UNITED STATES PATENT AND TRADEMARK OFFICE

Office Action Summary	Application No. 10/580,620	Applicant(s) BARON ET AL.	
	Examiner Shantese L. McDonald	Art Unit 3723

DETAILED ACTION

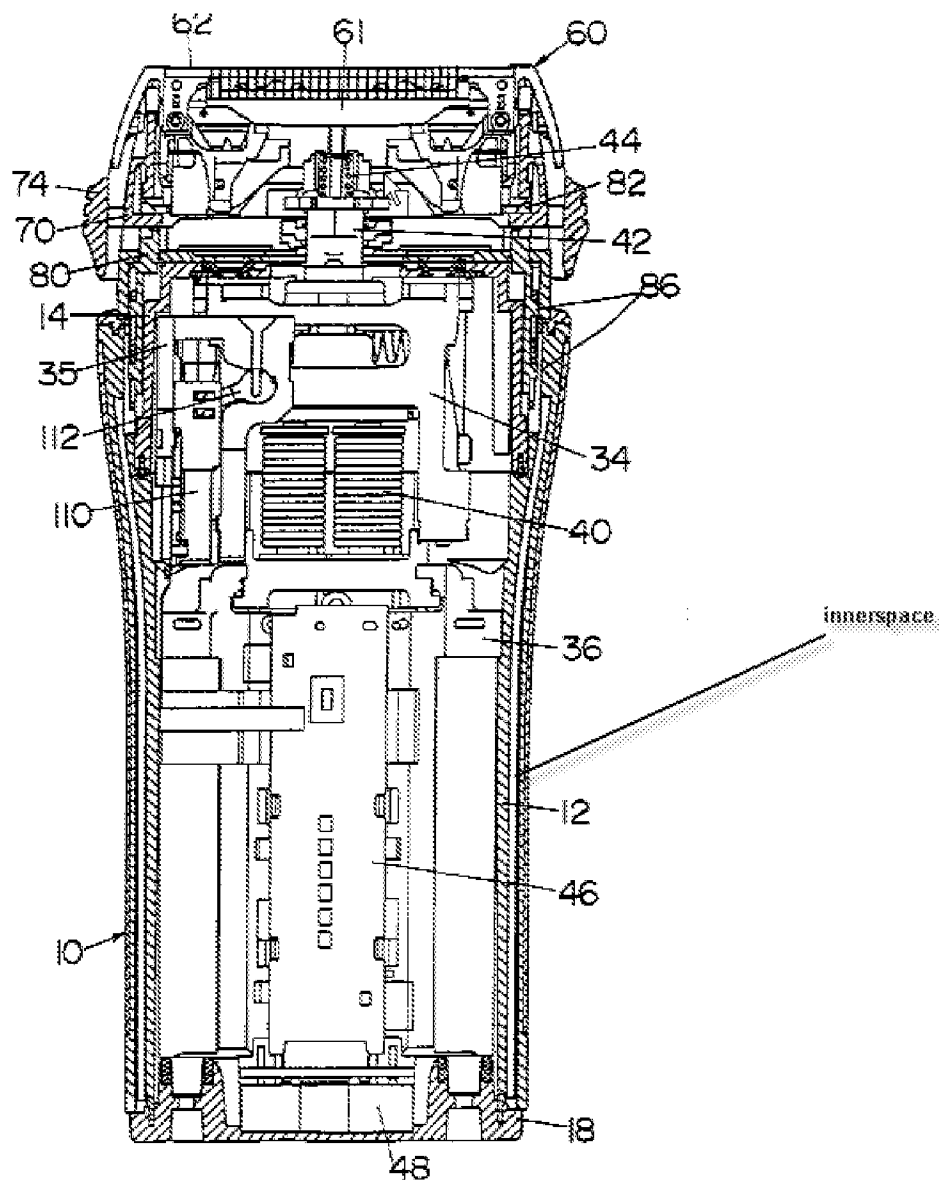
The Applicant argues that the shell structure, 14, does not envelope at least a circumference of the housing behind the at least one shaving head. The Examiner disagrees. The housing, 12, of Taniguchi is described as being a tube having an upper shell and a bottom cover, and the upper shell and the bottom cover closing the top and bottom of the tube in a water-tight fashion to seal the motor, (col. 6, lines 32-54, fig. 4B). Taniguchi teaches that the shell, 20, covers the housing, 12. As shown in fig. 4B, the shell, 20, envelops at least the front half of the housing, which can be considered as, at least a circumference of the housing. The Examiner notes that the claim limitation is,

"at least a circumference", and not the whole circumference of the housing, and this arrangement is located behind the shaving head.

The Examiner notes that the Taniguchi reference does indeed teach an interspace left between the housing and the shell portions. Taniguchi teaches that the upper shell, 14, bottom cover, 18, and the tube 12, close the top and bottom openings of the tube in water tight fashion, (col. 6, lines 33-40). Therefore it means that there is a space between the housing shell, 10, and the housing, 12, as depicted in fig. 2, since the specification of Taniguchi doesn't state that the shell, 10 and the housing, 12, are put together in a water tight fashion, and if water can fit in that space, then there has to be a inner space, (see the marked up figure).
